## Review of the Lake Ontario-St. Lawrence River Studies

*Review of the*  
**Lake Ontario–St. Lawrence River Studies**

Near the middle of the final year of the 5-year LOSLR Study, the IJC asked the U.S. National Research Council (NRC) and Royal Society of Canada (RSC) to provide an independent scientific review of selected LOSLR studies, reports, and models. The NRC and RSC agreed to review the LOSLR Study materials in terms of their appropriateness and sufficiency to inform decisions related to regulation plan options. The IJC presented the committee with documents on the Shared

FIGURE 2-3 The Board Room interface. SOURCE: Board Room, Toronto Board Room April 24.xls (SVM 2).

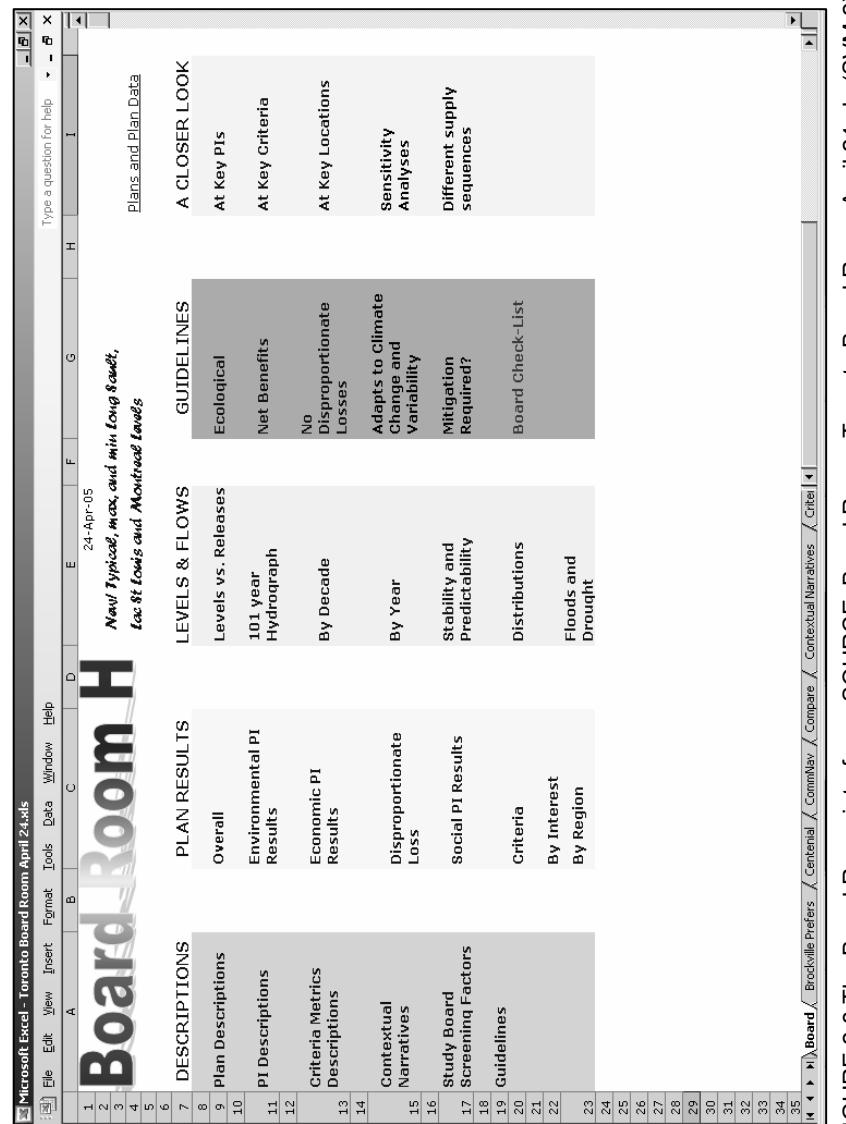
Many of these displays are creative and useful. Some, like the circular ratio plots, allow comparison of a wide suite of performance indicators (Figure 2-5), while others present data aggregation problems that will be elaborated in chapter 4.

Although the Board Room is an excellent idea for communicating the results of the SVM modeling process to decision makers and stakeholders, it does not yet live up to its full promise. For example, the Board Room lacks an introduction on its homepage or a detailed user's manual, and it has some broken links. More substantively, some of the broken links are on important and relevant aspects of the

FIGURE 3-3 Cosmos modeling of cumulative recession (FEPS 7, p. 11).

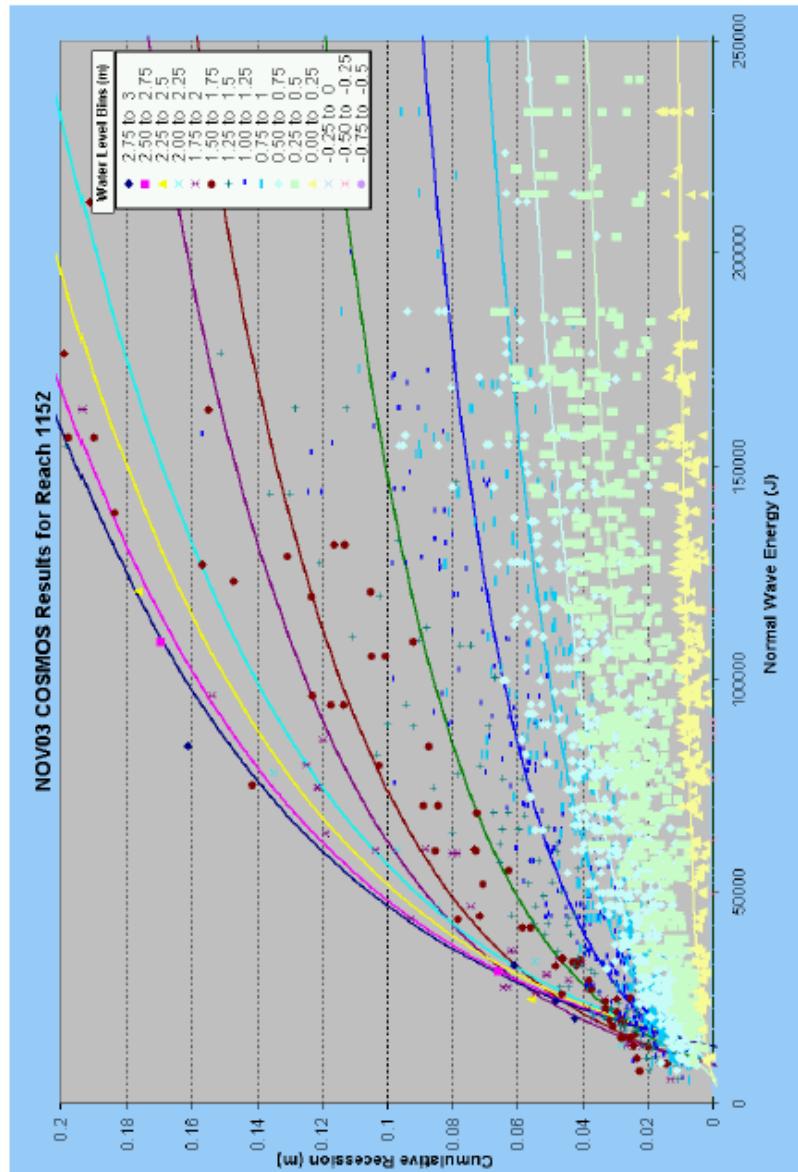
- e) The data used for fitting the regression for recession displays high variability (fig. 3.6) (FEPS 7). Figure 3.6 indicates very high variability of data used for the regression. The quality of the fit and the error do not appear to have been assessed (at least it has not been documented)

The uncertainty in the logarithmic regression equation is the most problematic aspect of the FEPS study because of its capacity to introduce and propagate error. All downstream modeling considerations are dependent, in part, on the logarithmic regression output. This dependence places critical importance on those output values being accurate; otherwise error will be propagated through the downstream models. Another problem stems from the use of the synthetic data set of monthly normal wave energy calculated by WAVAD and monthly recession calculated by COSMOS. The fit for the recession regression equation uses these data. Using synthetic data introduces unnecessary error (E1) on recession outputs, which subsequently are used as inputs for the regression analysis. Regression analysis produces its own error (E2) resulting in the aggregate error of E1+E2. The first type of error (E1) could presumably have been avoided by skipping the COSMOS process and using the observed recession data instead.

The uncertainty in the data used to derive the logarithmic relationship exhibits a great deal of scatter (Figure 3.6 of FEPS 7, p. 11, reproduced below, Figure 3-3). The horizontal axis extends to 250,000 J/m<sup>2</sup> and covers the range of the average yearly normal wave energy. However, the WAVAD model predicts January wave energy in excess of 600,000 J/m<sup>2</sup>. The rate of change of the predicted recession decreases rapidly as wave energy increases. This implies that recession during severe winter storms will be similar to that for significantly lesser storms. From the materials presented for review, it was not possible to determine whether this feature of the model is reasonable. Thus calibrating the recession regression equations

FIGURE 4-1 Distribution of wetlands by geomorphic types in Lake Ontario and the St. Lawrence, with respect to a) total area and b) total number.

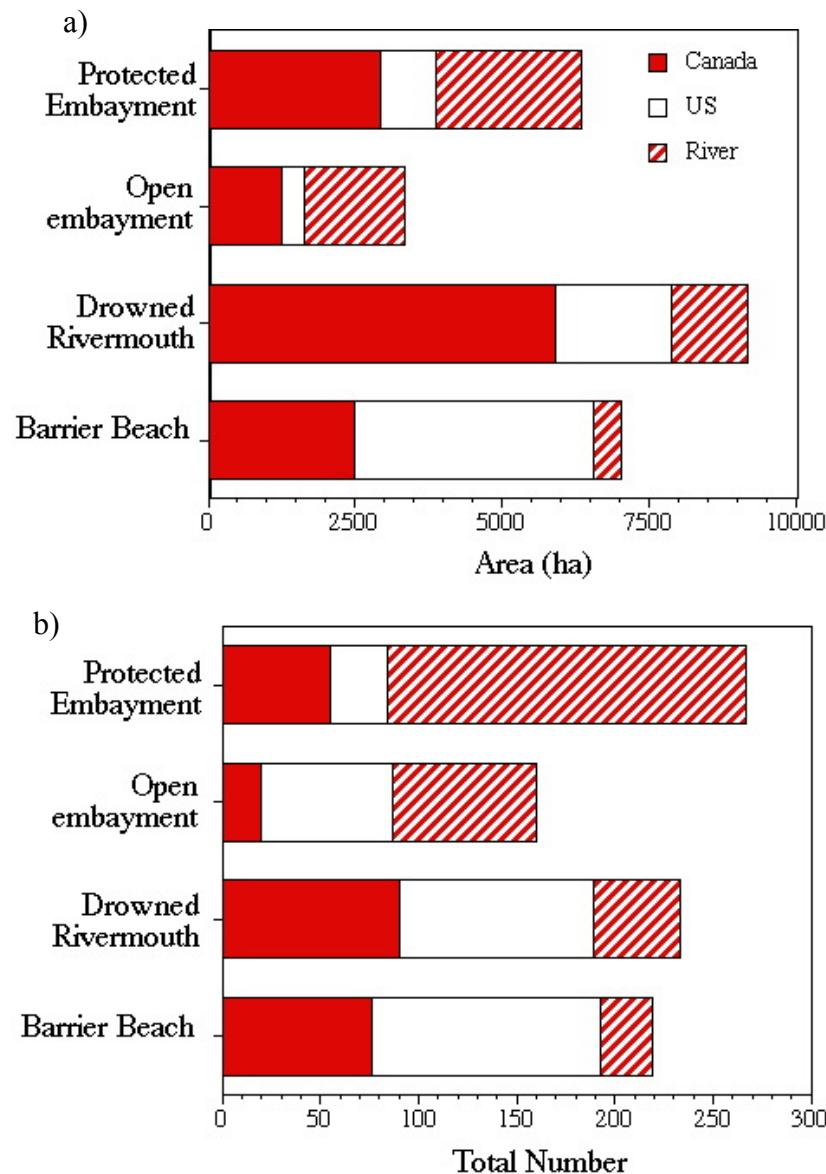
There are very few open embayments in Lake Ontario, and most of these occur in the U.S. and along the river (Figure 4-1). The average size of wetlands in the U.S. ranges from 6 ha for open embayments to 35 ha for barrier-beach wetlands. By comparison, the average size of Canadian wetlands is much larger, 33 ha for barrier-beach to 66 ha for drowned river mouth marshes. The average size of riverine wetlands tends to be intermediate, from 21 to 39 ha (Table 4-1). Compared with what is available, the average size of wetlands sampled in this project was between 19 and 46 ha, generally much larger than the average wetland in the United States, except for the barrier-beach type (Table 4-1). Unfortunately, the degree to which these untested assumptions of representativeness contributed to error propagation is unknown. **A thorough analysis of the wetland study should document how well the sampled sites represent wetlands across Lake Ontario and the St. Lawrence River**
